UNITED STATES PATENT AND TRADEMARK OFFICE

APPLICATION NO.	FILING DATE	FIRST NAMED INVENTOR	ATTORNEY DOCKET NO.	CONFIRMATION NO.
10/714,209	11/14/2003	Mario Loncar	P03,0429	2550

Office Action Summary	Application No. 10/714,209	Applicant(s) LONCAR, MARIO	
	Examiner Teena Mitchell	Art Unit 3743

DETAILED ACTION

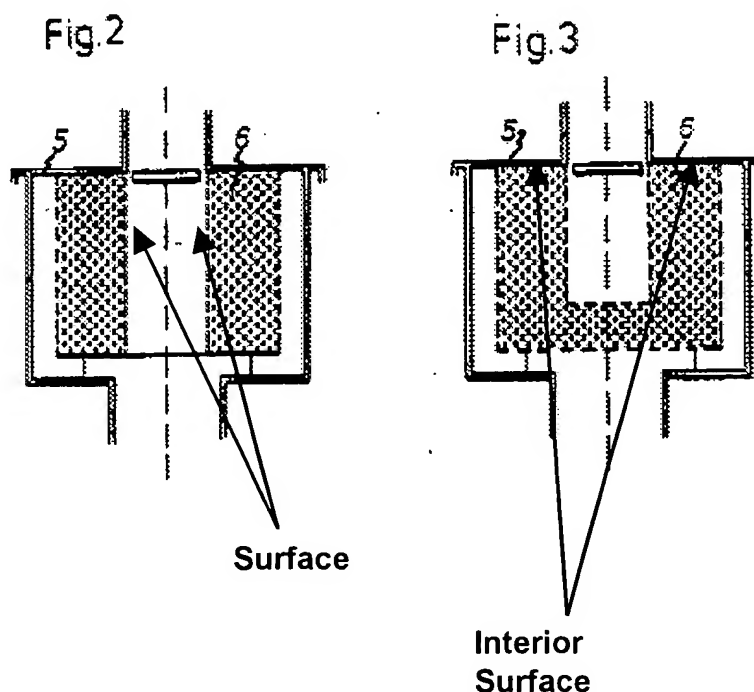
Werner in a tube (Figs. 2-4; based on standard dictionary definition of tube: "A hollow cylinder, esp. one conveying a fluid or functioning as a passage" Werner is readable upon a tube because there is a passage for delivery of fluid (i.e., a gas)) discloses a housing having a cross-sectional area adapted for gas flow there through (note dashed line in Figs. 2-4); and an absorber for carbon dioxide disposed inside said housing (6) and having a surface facing said gas flow disposed to allow interaction of said absorber with said gas flow to absorb carbon dioxide from said gas flow, while presenting substantially no impediment to said gas flow (Figs. 2-4). As to the limitation of the tube being substantially cylindrical. At the time the invention was made, it would have been an obvious matter of design consideration to have the housing substantially cylindrical because Applicant has not disclosed that having the housing substantially cylindrical provides an advantage. One of ordinary skill in the art furthermore, would

have expected Applicant's invention to perform equally well with the housing other shapes because as long as flow of gas is not impeded the device would perform the same. Therefore, it would have been an obvious matter of design consideration to modify Werner to obtain the invention as specified in claim 1.

With respect to claim 2, Werner discloses wherein said housing has an interior surface, and wherein said absorber is disposed against said interior surface (Figs. 2-4; see illustration of Figs 2, 3 below).

With respect to claim 4, Werner discloses wherein said absorber (6) has a substantially cylindrical shape and is disposed in a center of said housing coaxial with said housing (Figs. 2-4).
